Cala Homes

Land at Fiery Hill Road

Highways Review

Job Title	Land at Fiery Hill Road		
Job Number	J322540	Date	15/12/2015
Copy	Copy	File reference	151112 322540 AY
Prepared by	Alan Young	Approved by	David Frisby
Subject	Highways Review

CALA House Arleston Way Solihull B90 4LH Tel: 0121 711 5310 Fax: 0121 711 5311	
Site: Land off Fiery Hill Road Barnt Green			
Drawing Title: Fiery Hill Road Realignment Junction Visibility Analysis			
Drawing No: M00311/S278/103			
Revision: -		Scale: N.T.S @ A2	
Date: 15.12.2015		Drawn: CB

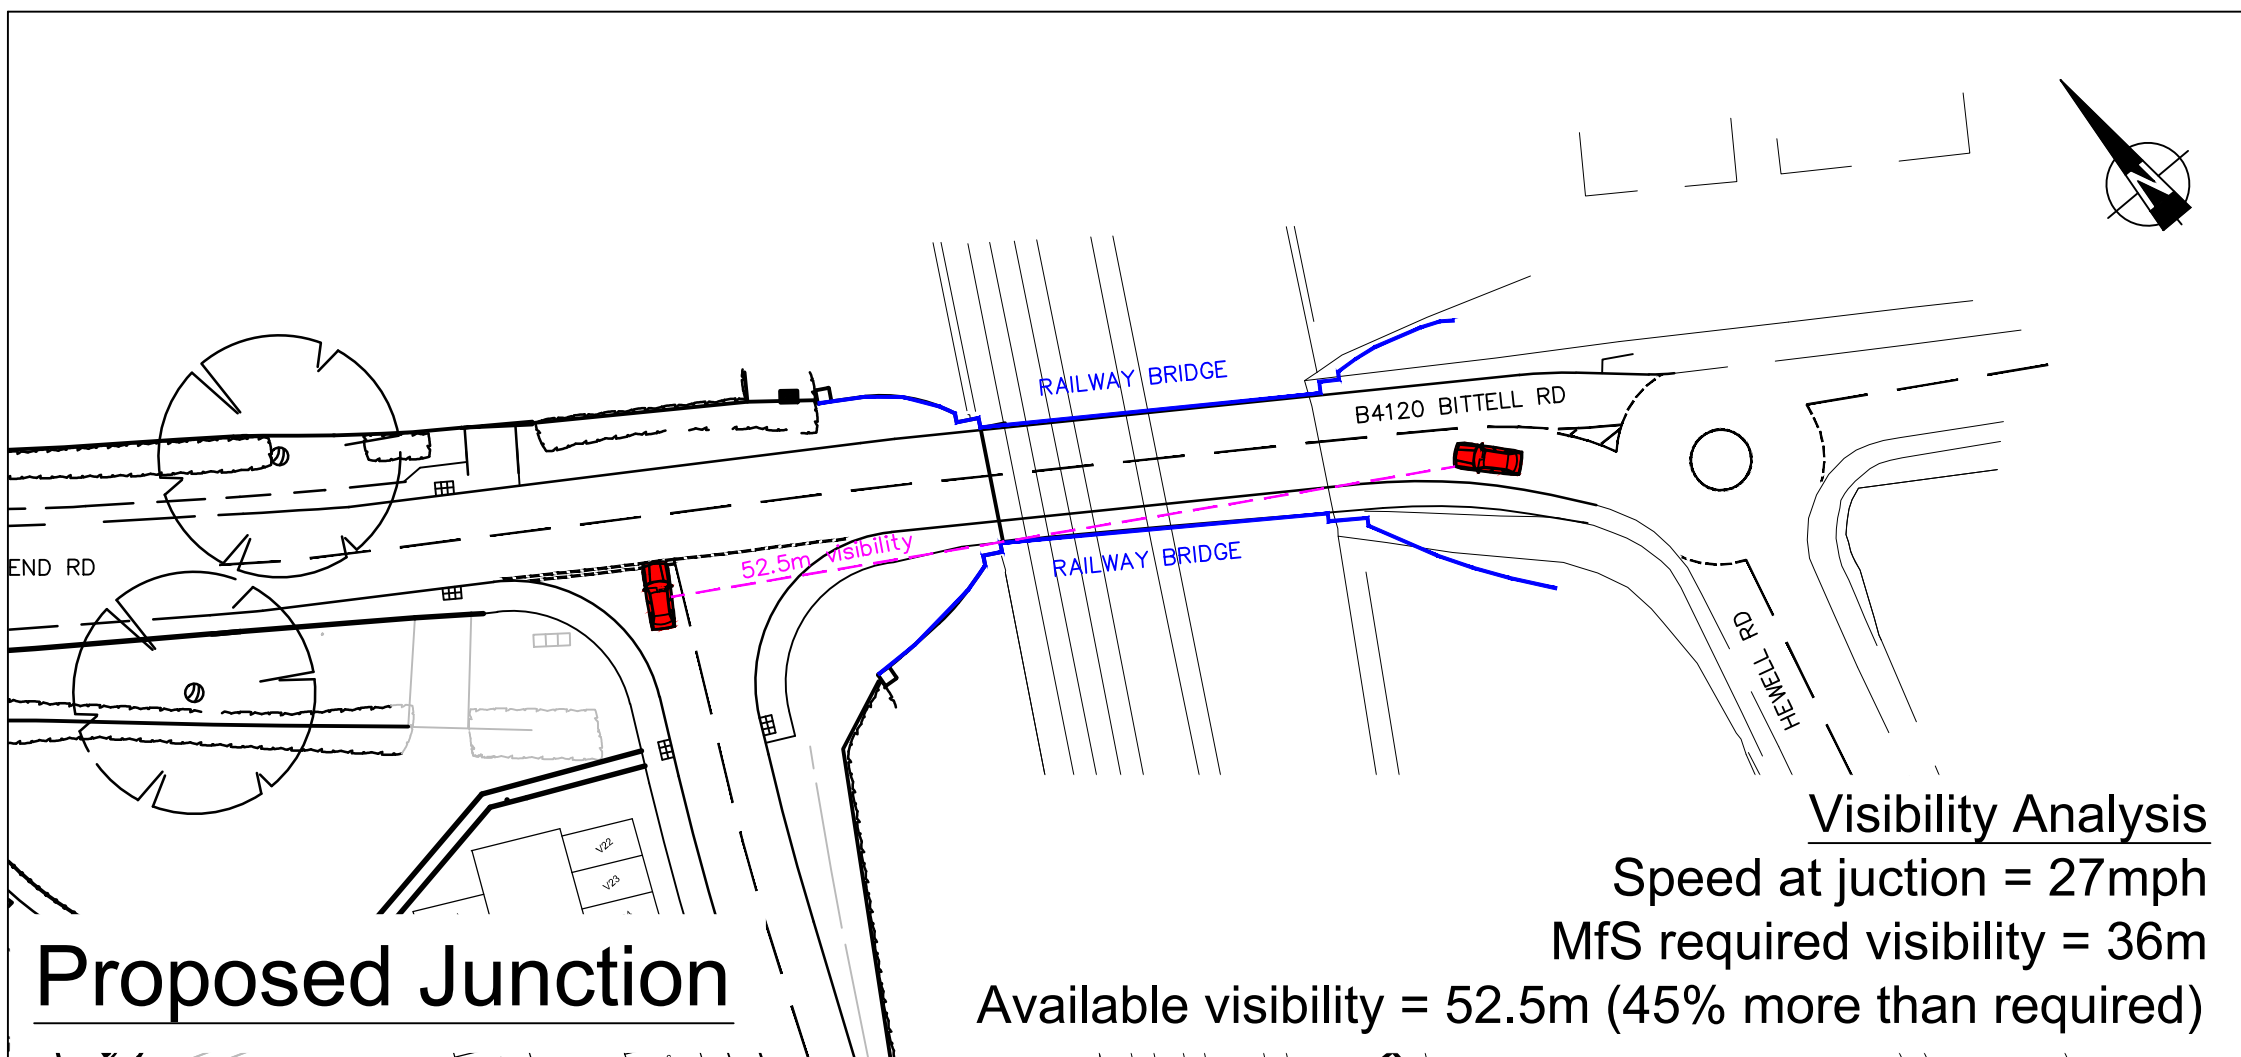
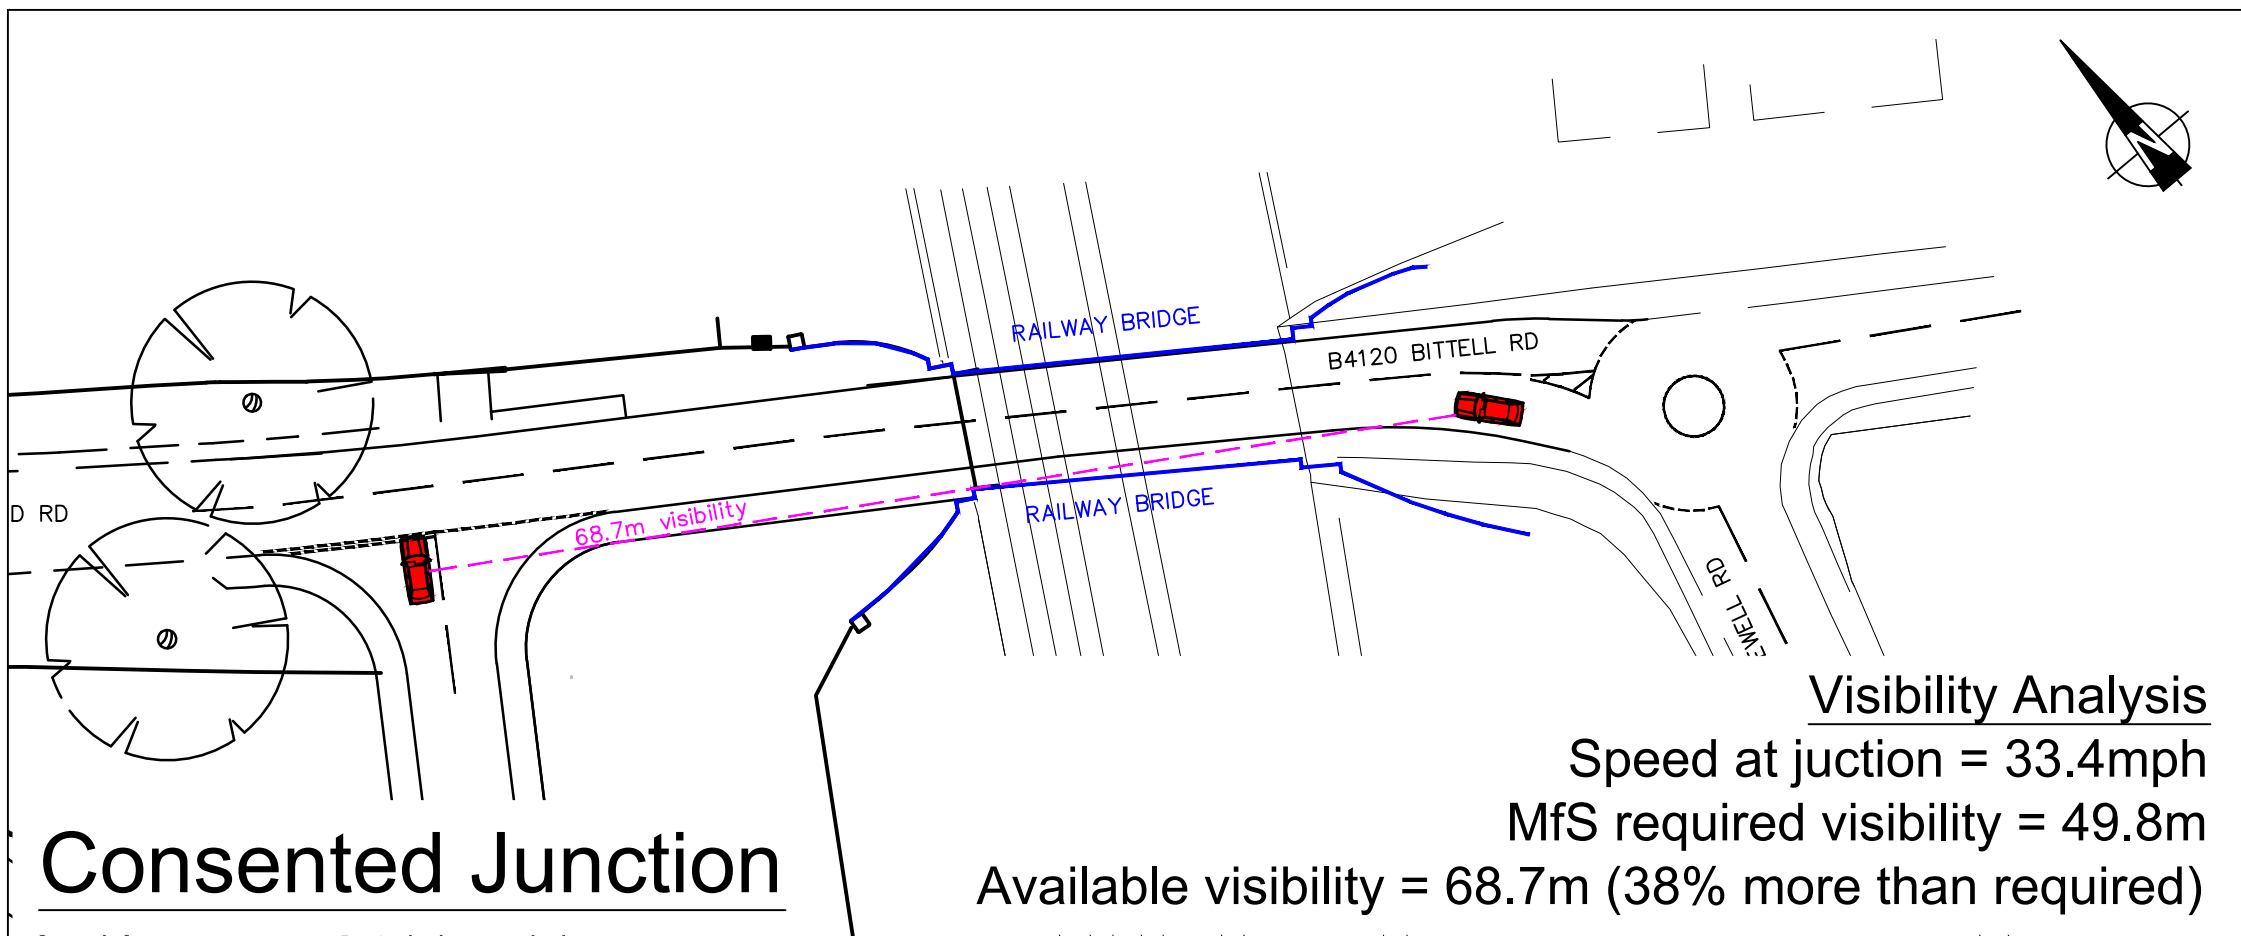
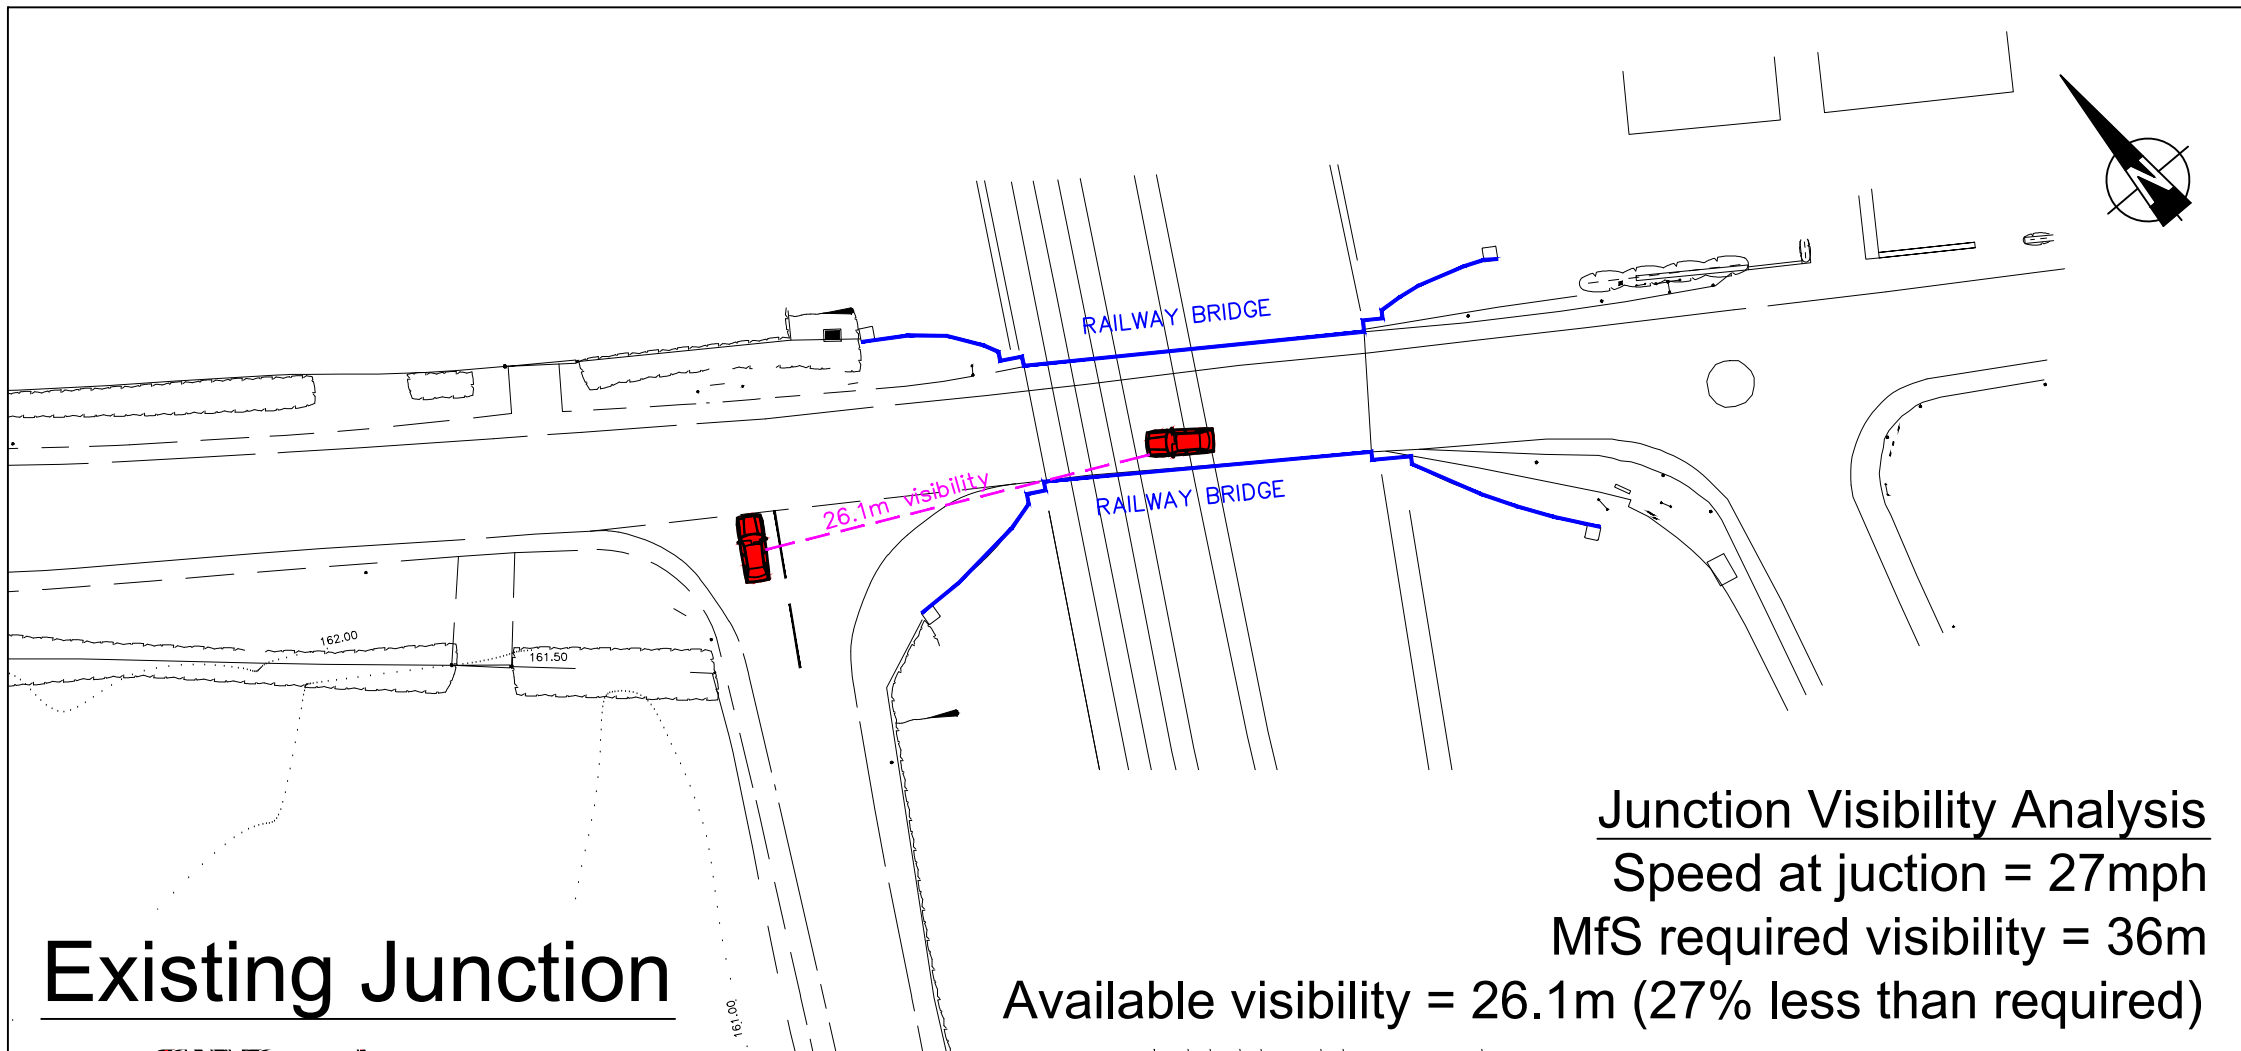
- 4.7 Drawing **M00311/S278/103** compares the required and available visibility in all three scenarios (existing, consented and proposed junction). It is clearly evident that the proposed junction provides a greater percentage increase in visibility (available compared to required) than the existing junction or the consented junction. Hence, the proposed new location is an improvement on the currently approved location.
